**AMAN HOTEL AND  
 RESIDENCES**  
 3425 COLLINS AVE.  
 MIAMI BEACH, FL 33140

**HPB - SEPTEMBER 16, 2025**

**APPROVED DESIGN FAILS TO MEET STRUCTURAL INTEGRITY STANDARDS**

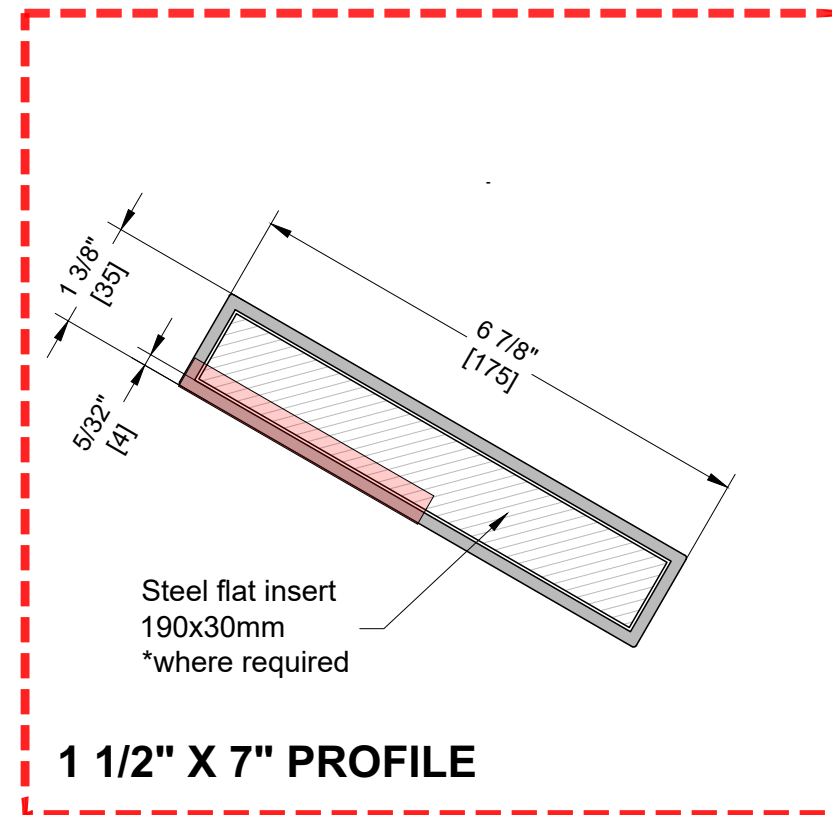
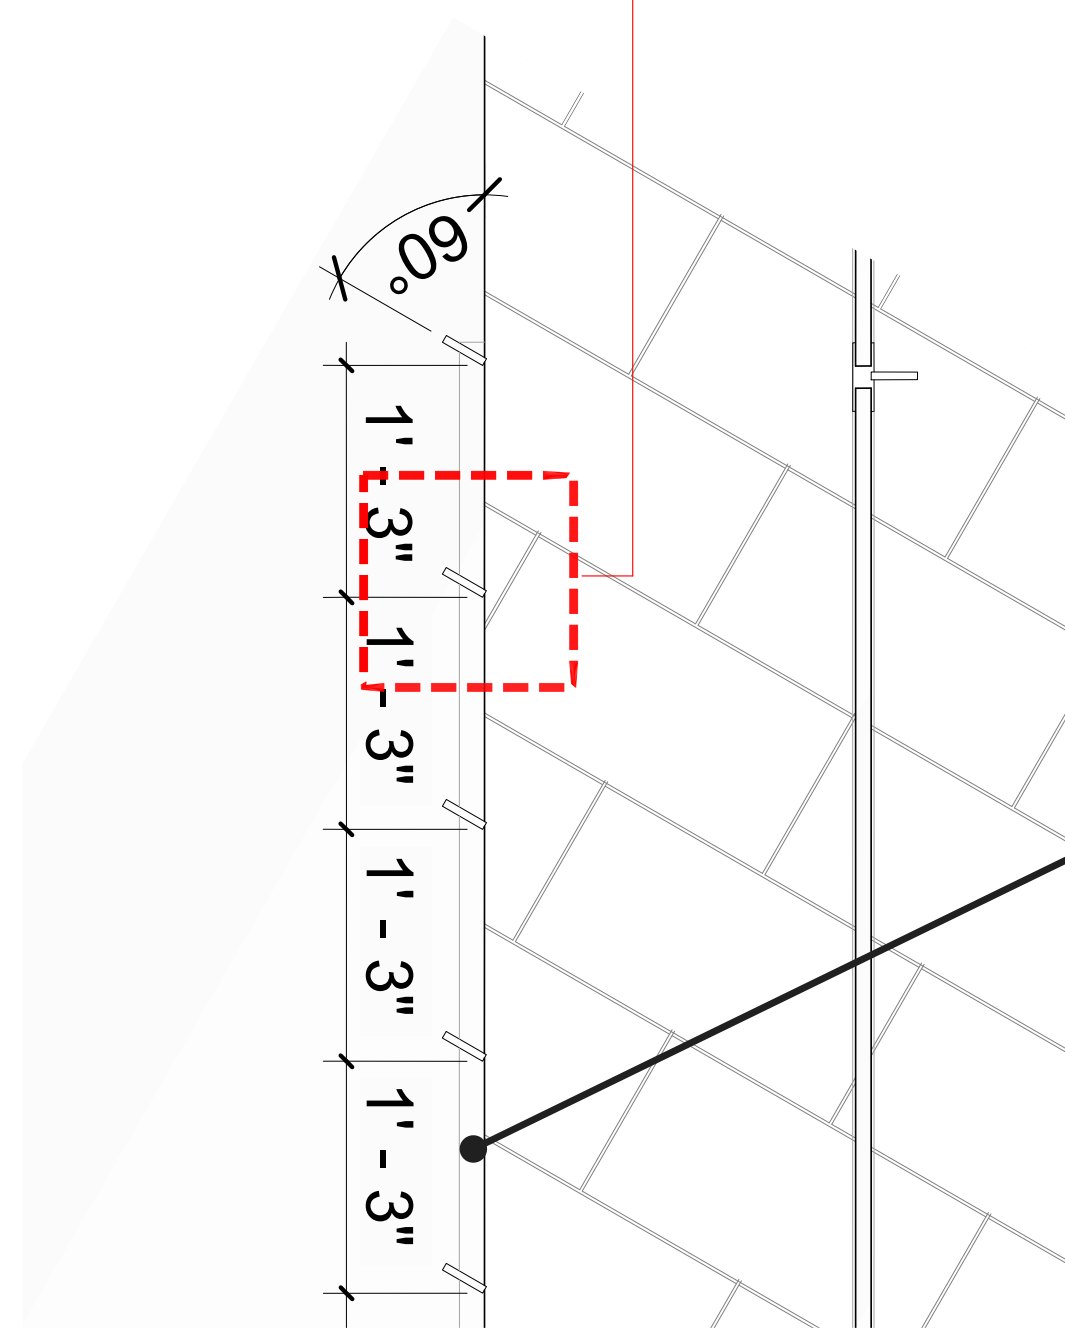
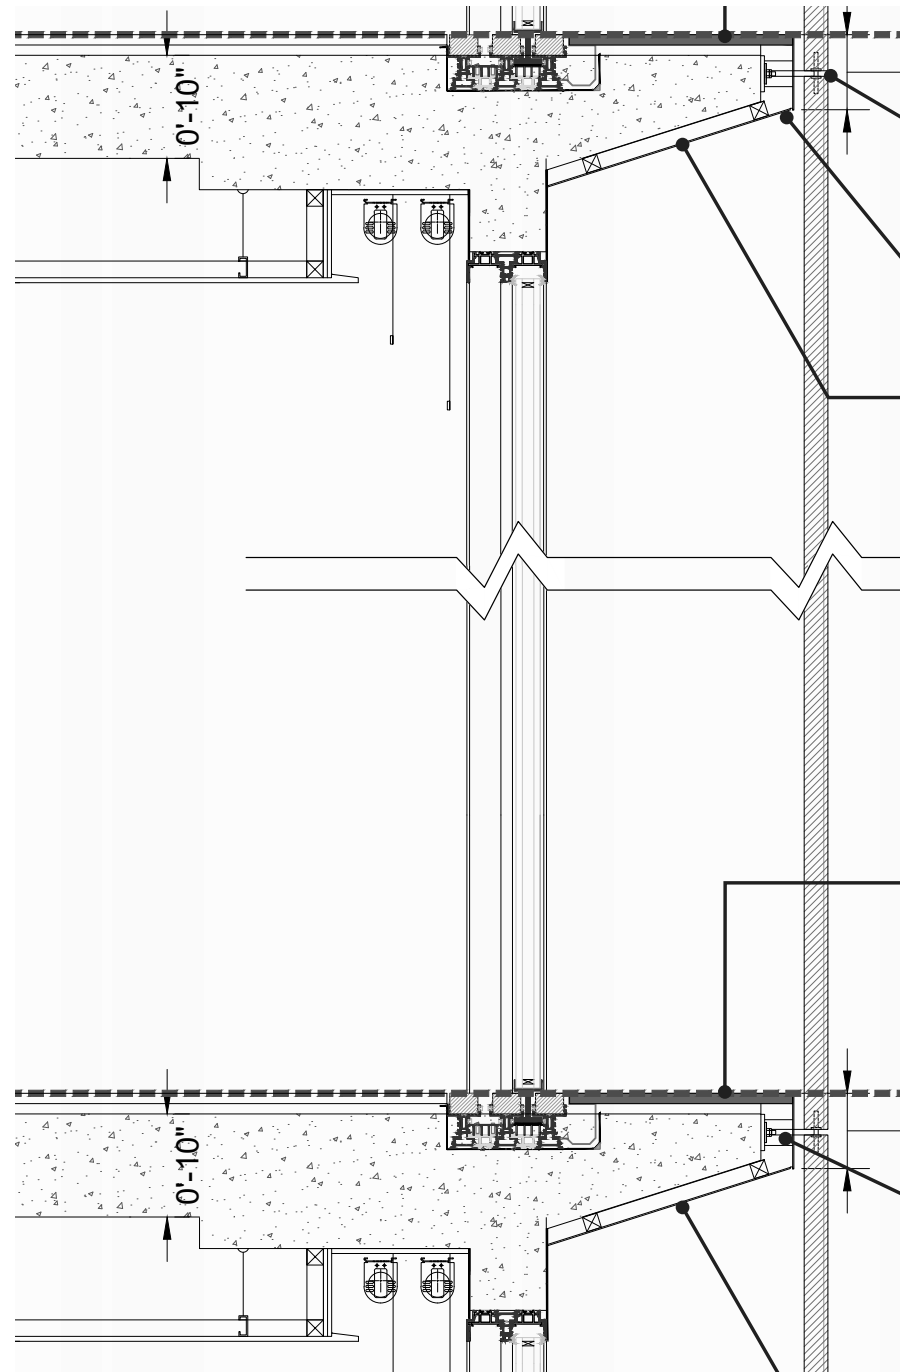
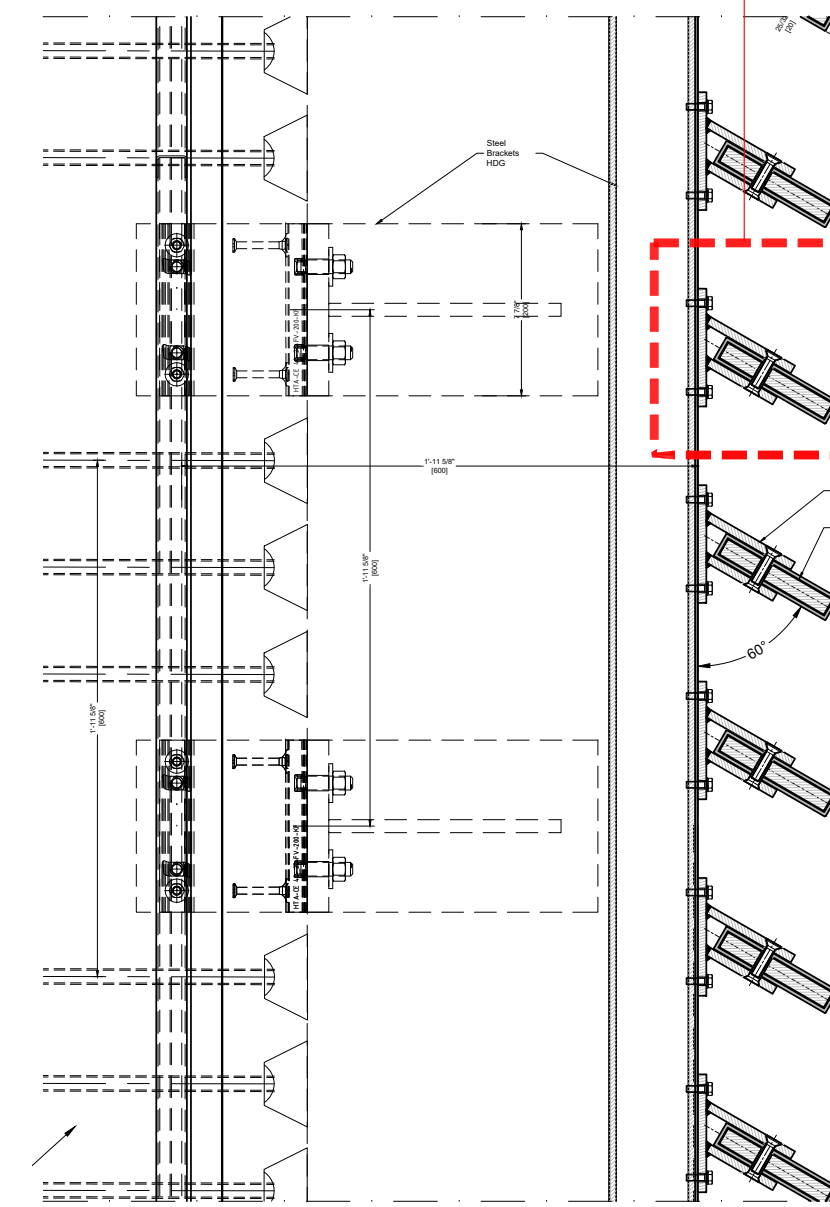
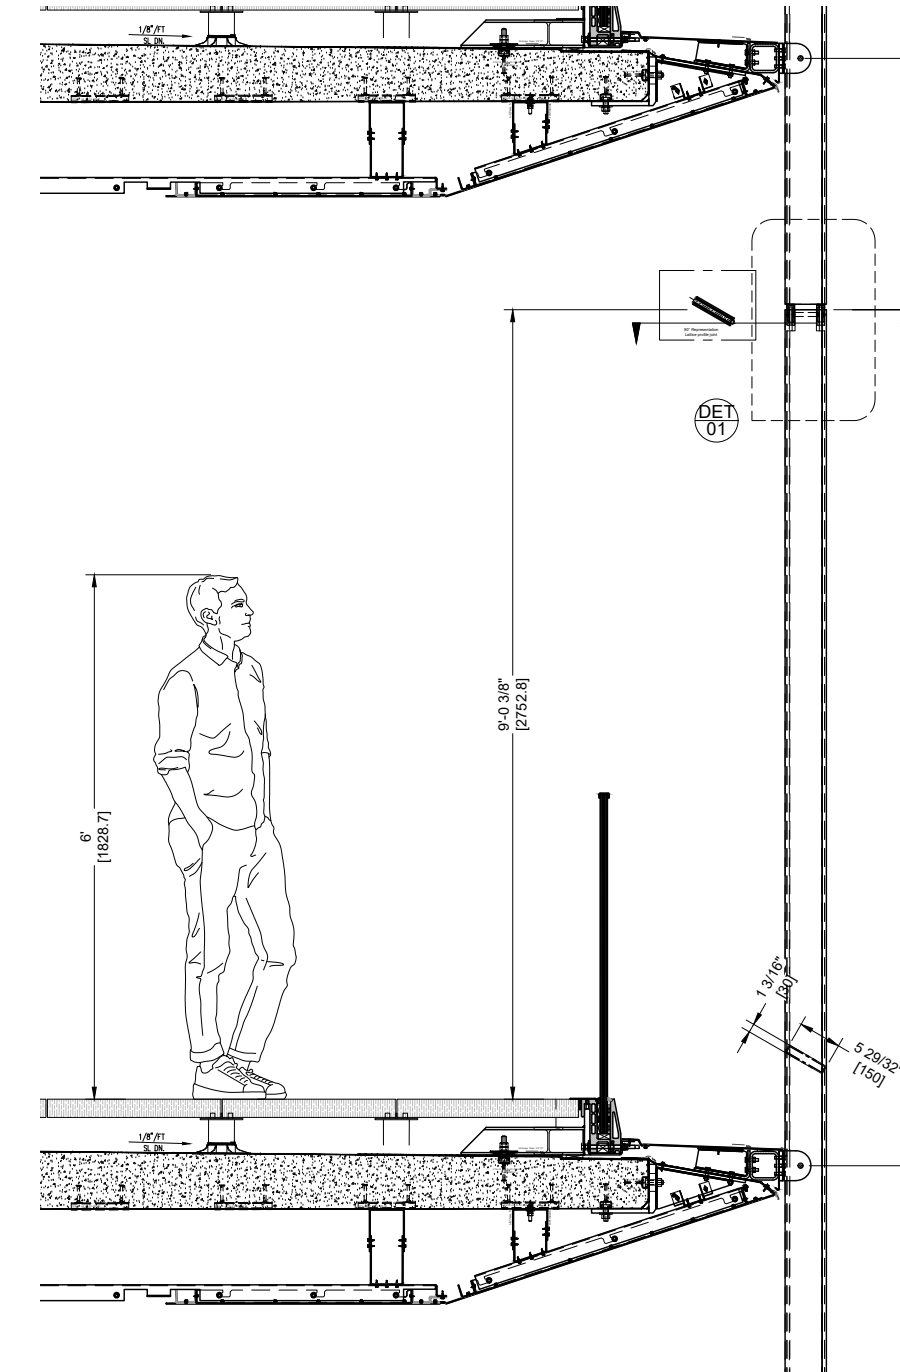
ORIGINAL LATTICE PROFILE PRESENTED **STRUCTURAL CHALLENGES** TENDING TO BEND UNDER LOCAL WIND LOADS.

THE PROFILE BECAME 6 TIMES **LARGER** THAN ORIGINAL CONCEPT WHEN ENGINEERED TO STRUCTURAL INTEGRITY STANDARDS DEVIATING FROM THE DESIGN INTENT.

1/2" X 3" PROFILE

1 1/2" X 7" PROFILE

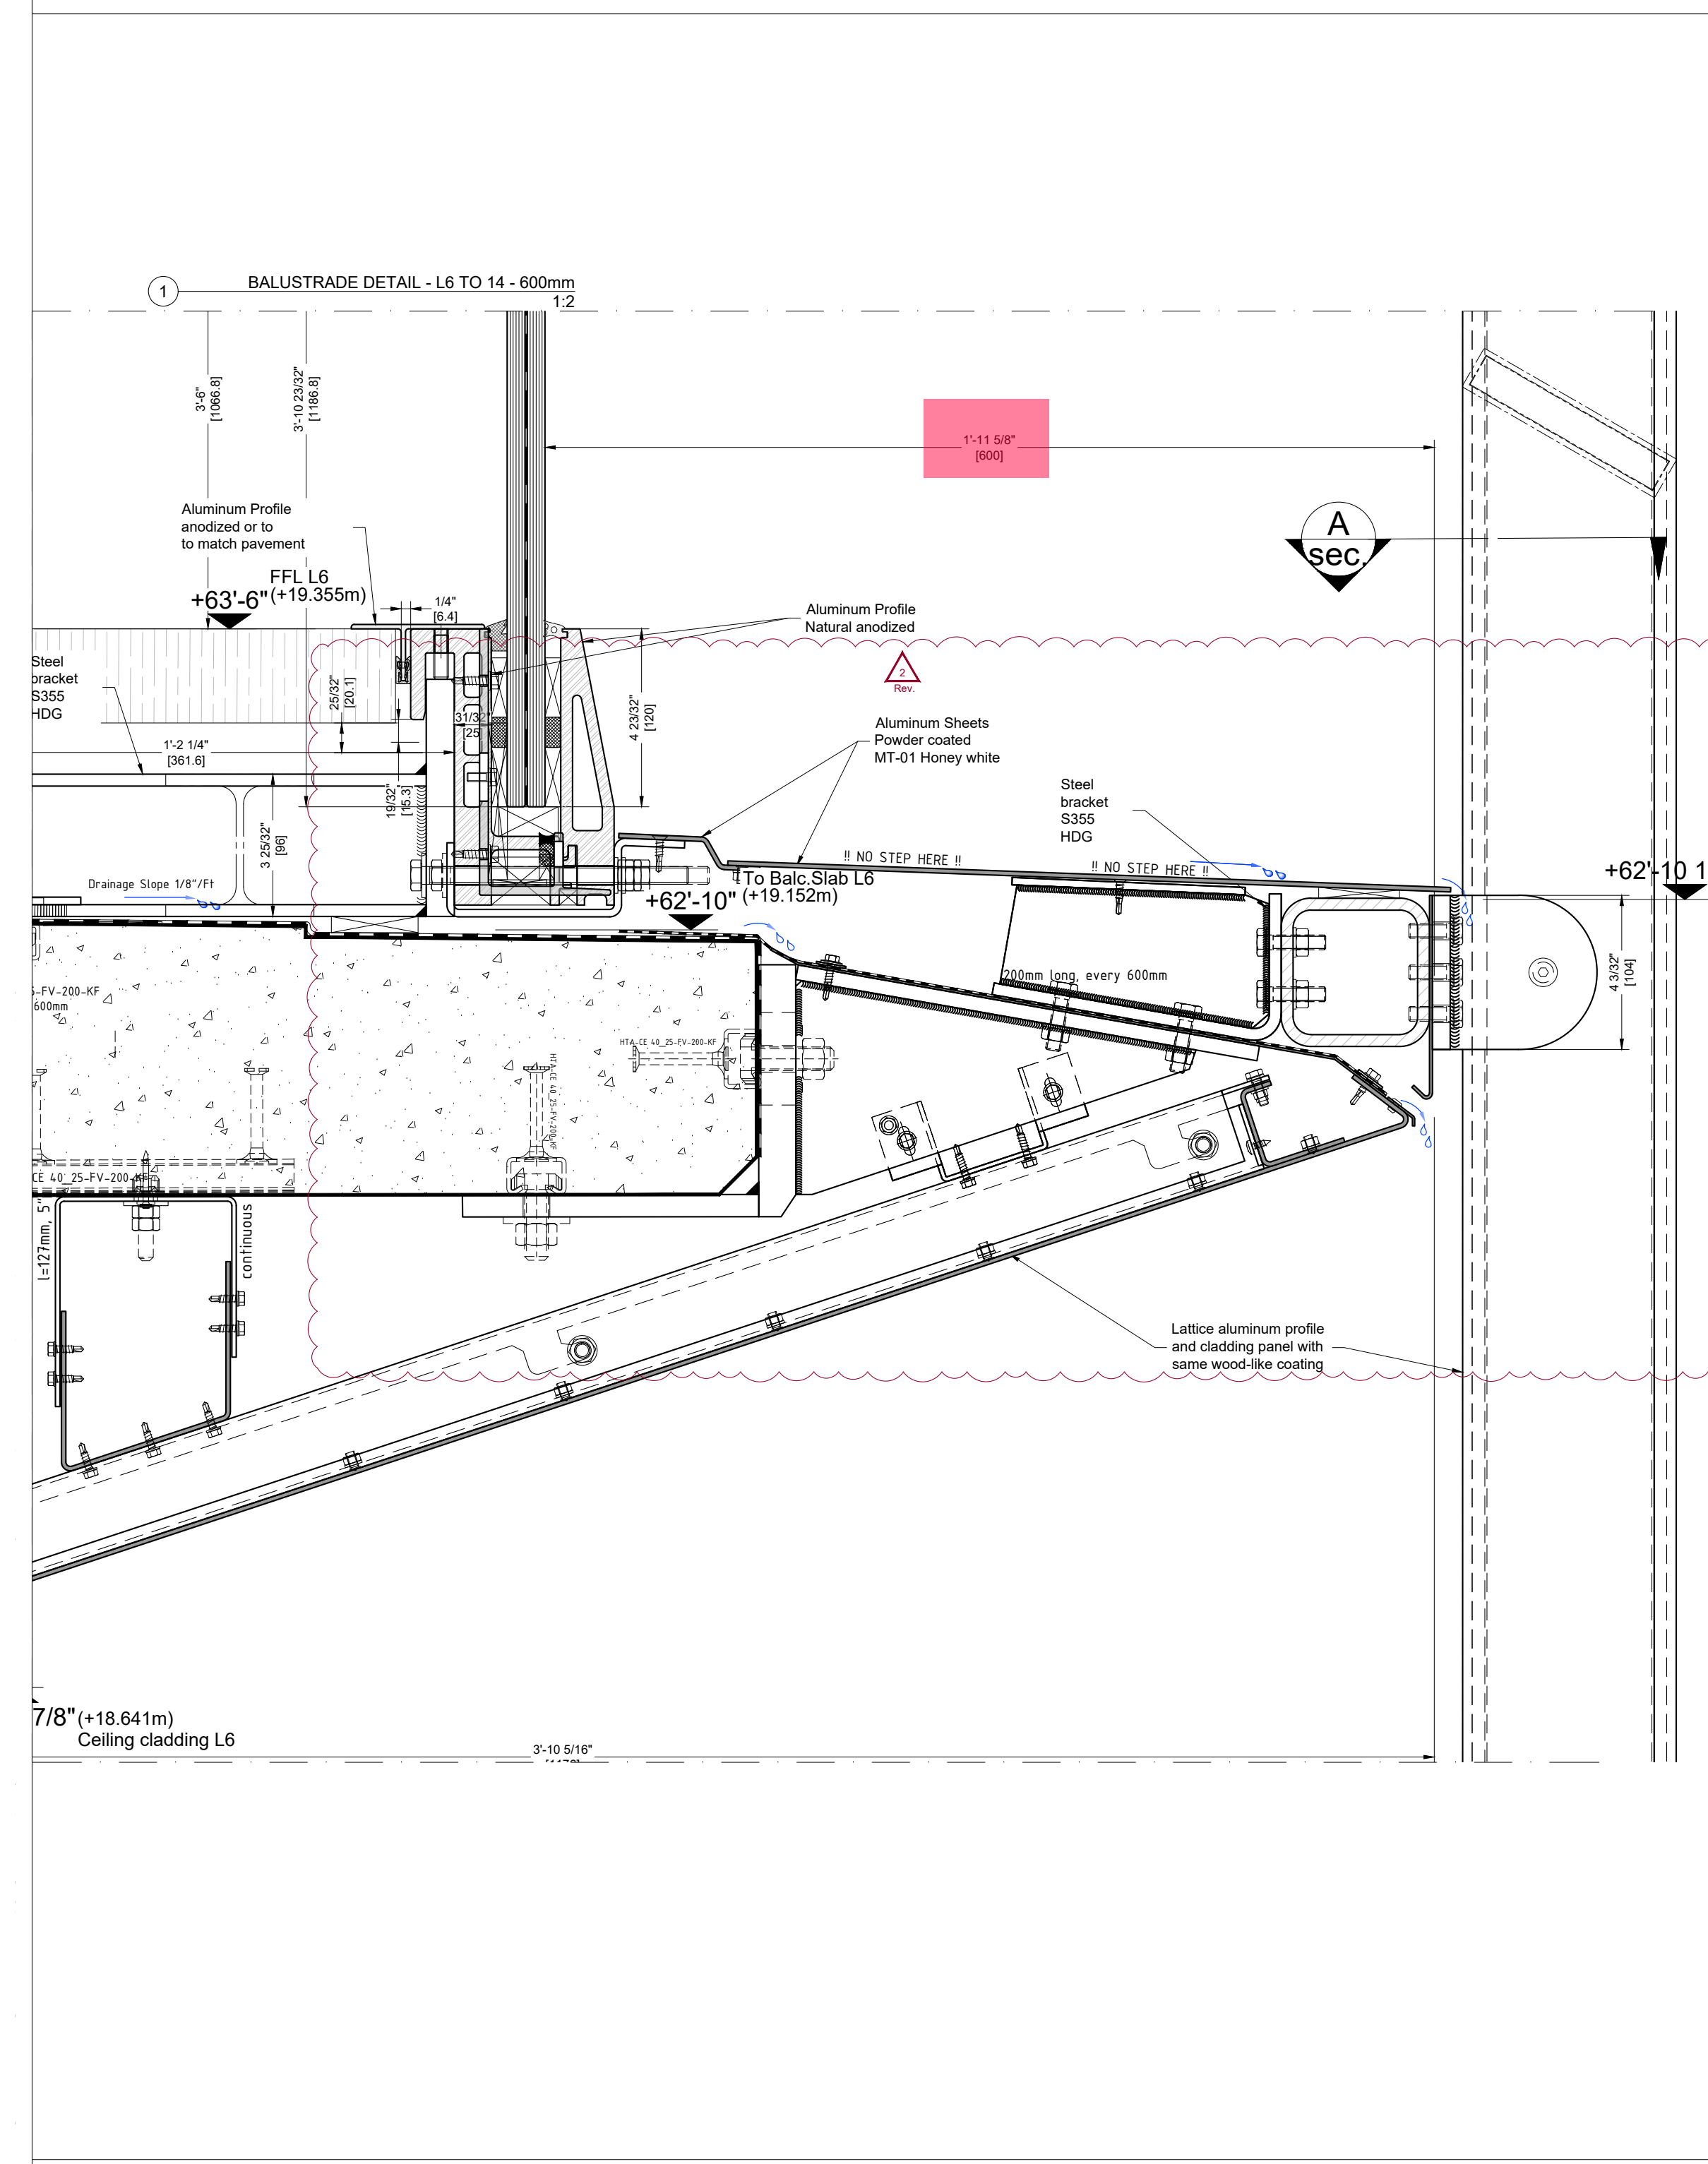
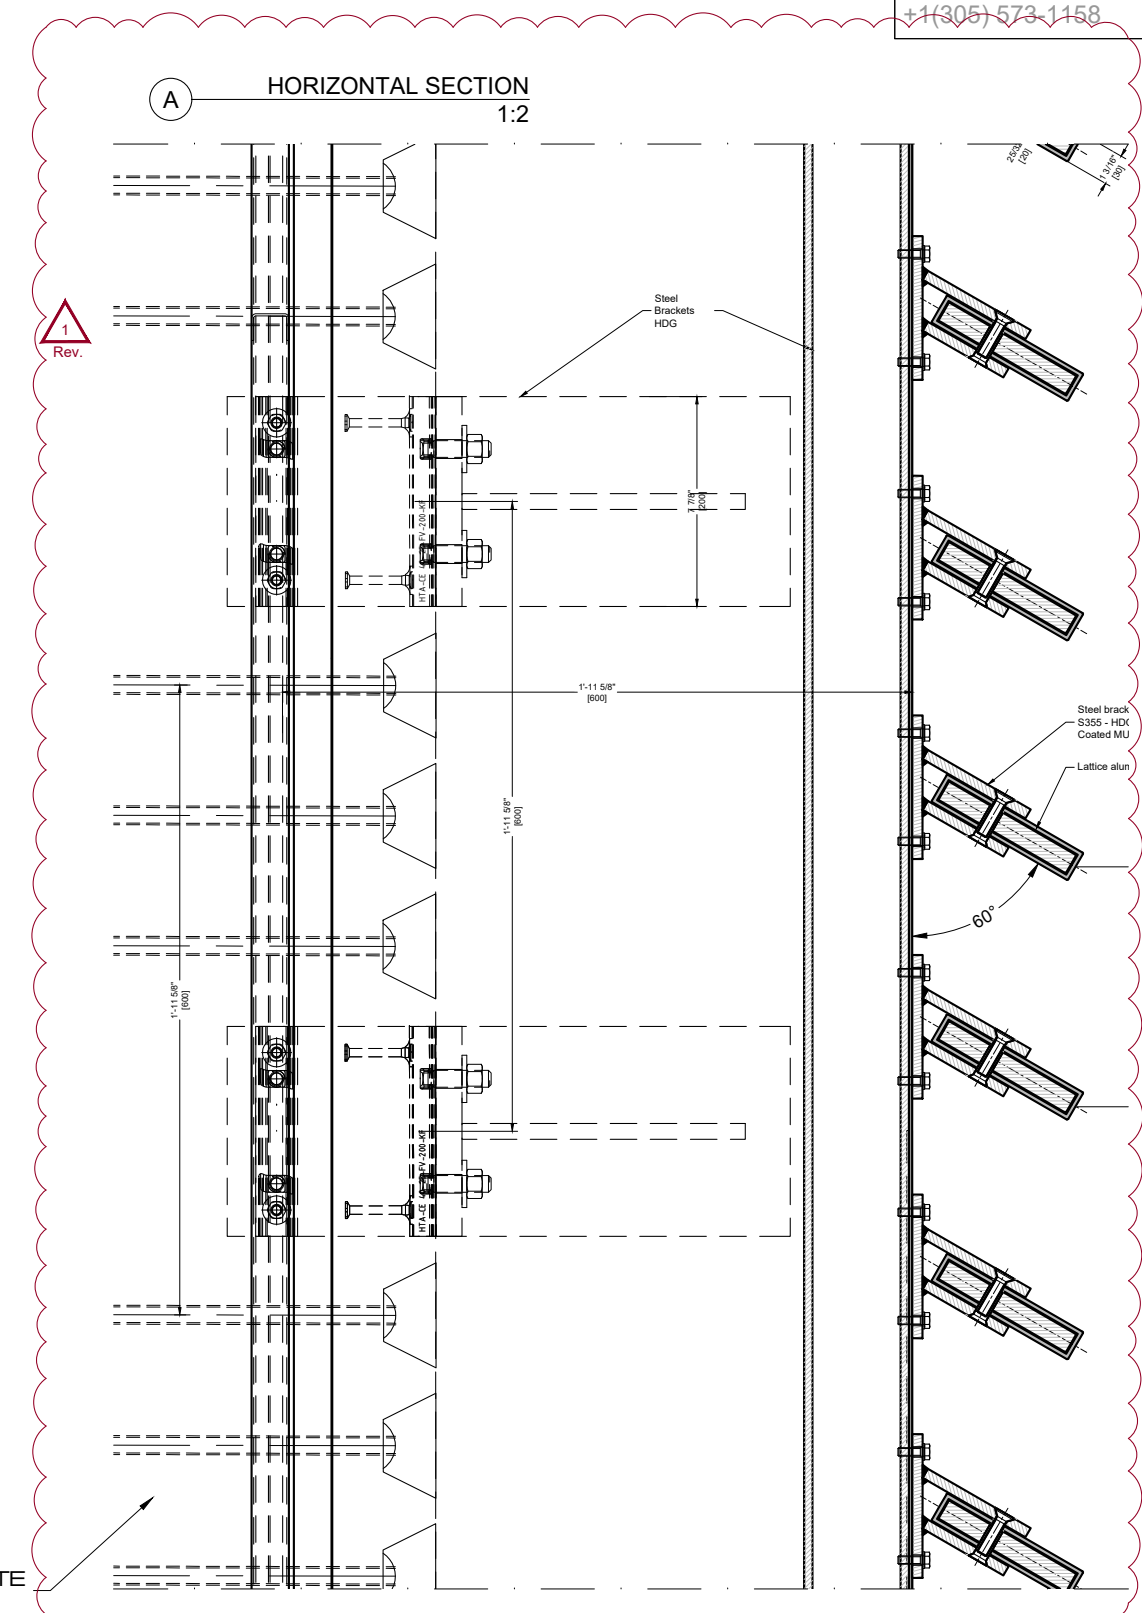
**ORIGINAL LATTICE PROFILE PRESENTED STRUCTURAL CHALLENGES** TENDING TO BEND UNDER LOCAL WIND LOADS.

THE PROFILE BECAME 6 TIMES **LARGER** THAN ORIGINAL CONCEPT WHEN ENGINEERED TO STRUCTURAL INTEGRITY STANDARDS DEVIATING FROM THE DESIGN INTENT.
